REMARKS

The Examiner is requested to please note the change in docket number from THE 0243 PUS to "2002P00193US" in further correspondence.

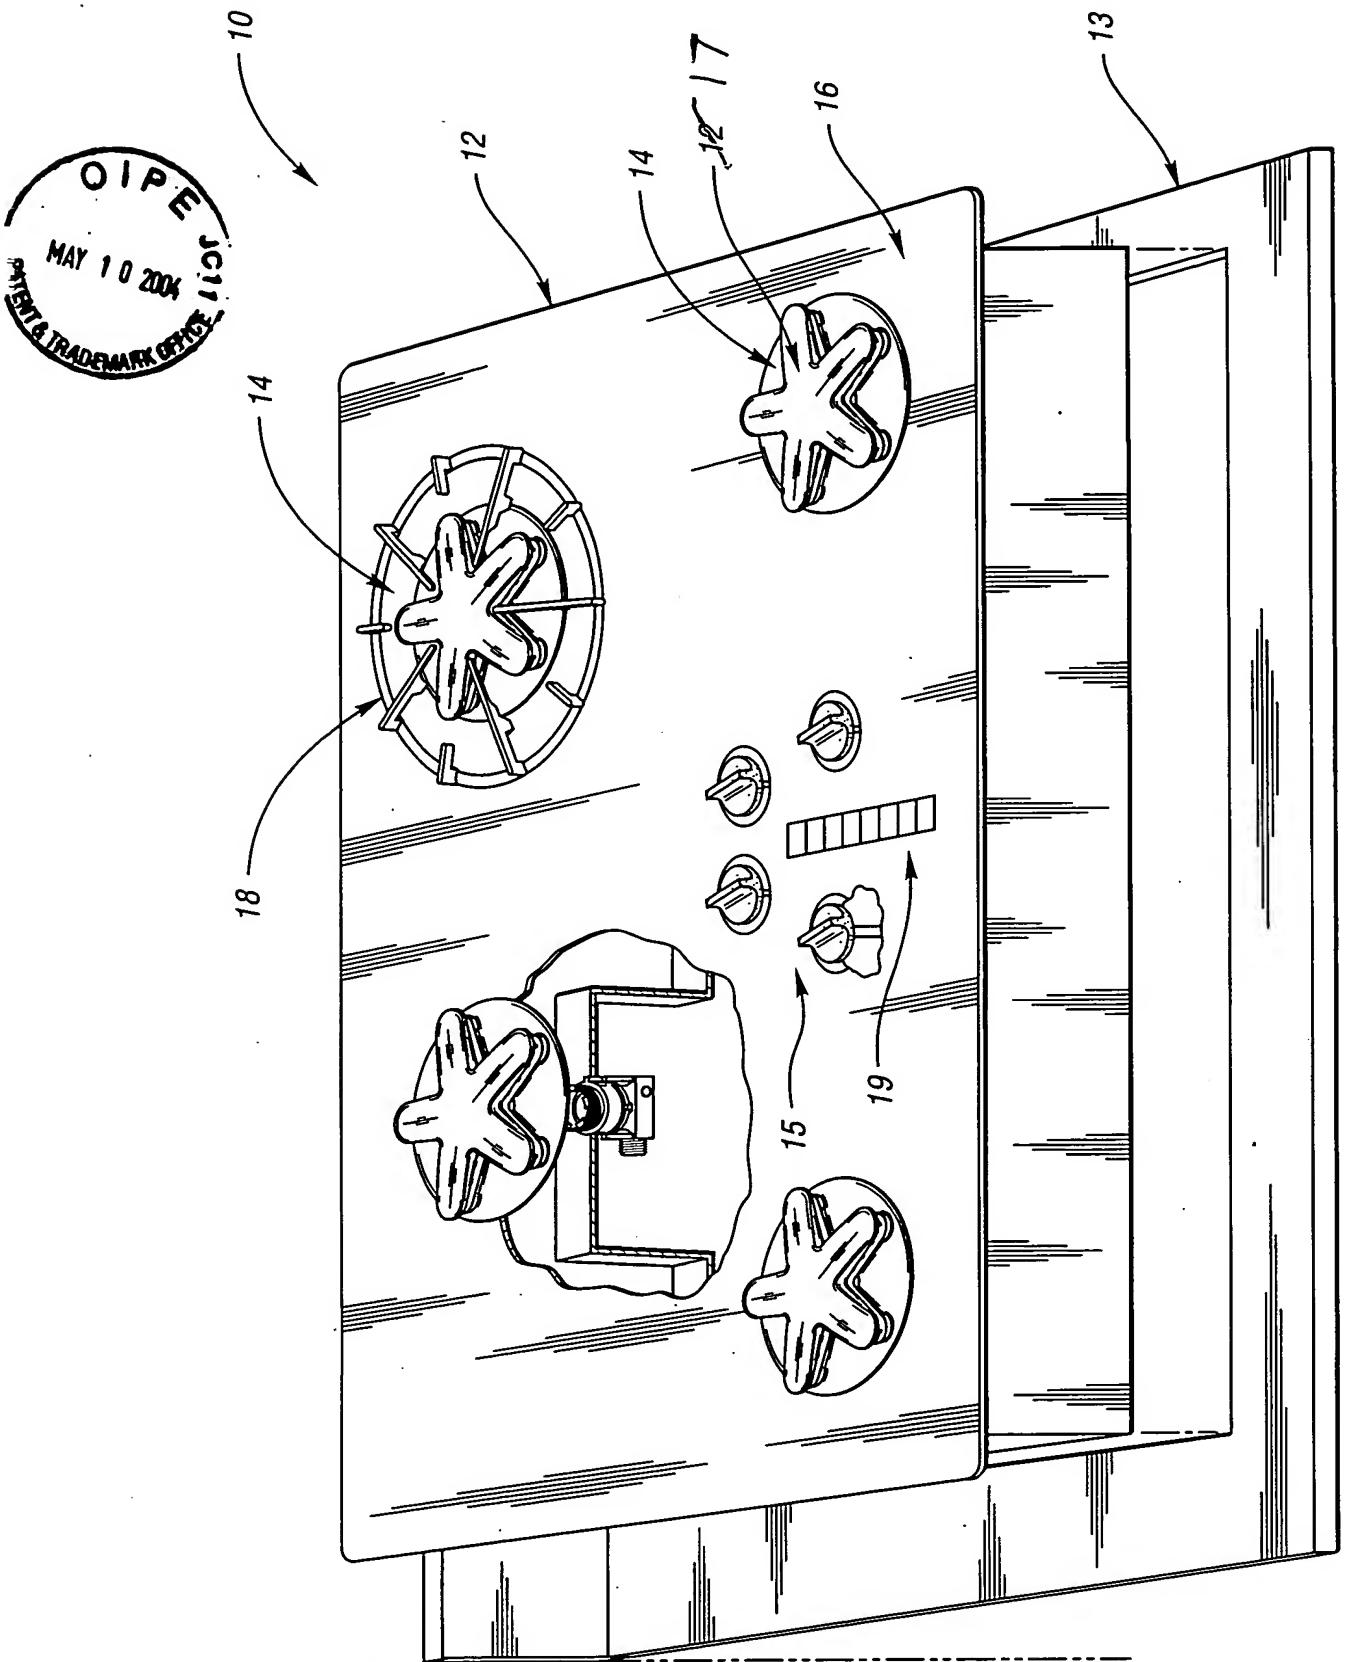
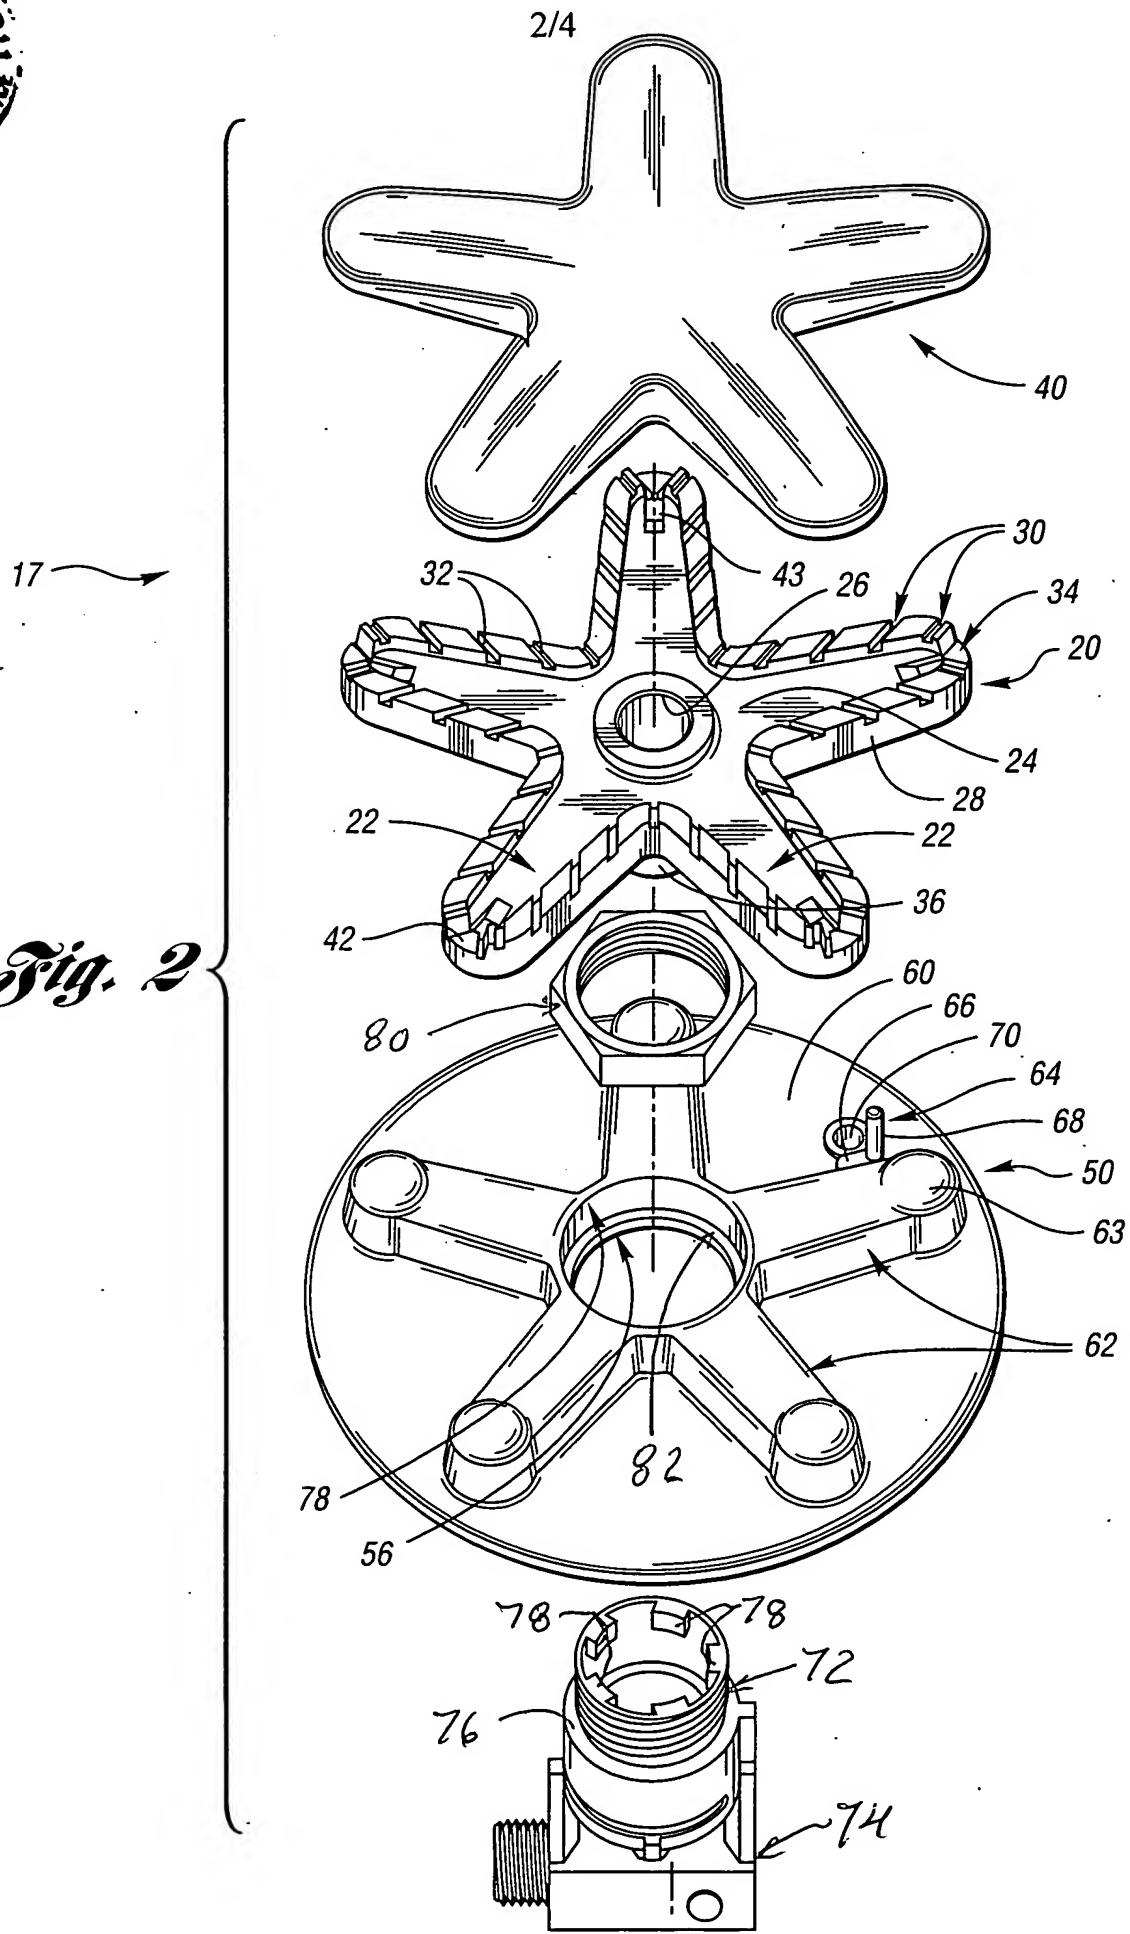
The Examiner objected to the drawings and the specification for failing to include reference characters associated with the "internal elements" which cooperate with the "indexer". These elements are the splines 38 on the stem 36 and the splines 78 inside the threaded sleeve 72, now properly illustrated on the amended drawings submitted herewith for the Examiner's approval. The elements are clearly illustrated interlocking in Figs. 6a and 6b. One minor correction is included to Fig. 1 to be consistent with the specification and the elements and minor corrections are also shown in corrections to Figs. 2 and 3. The attached amended drawings should clearly obviate the Examiner's objections to the specification and drawings.
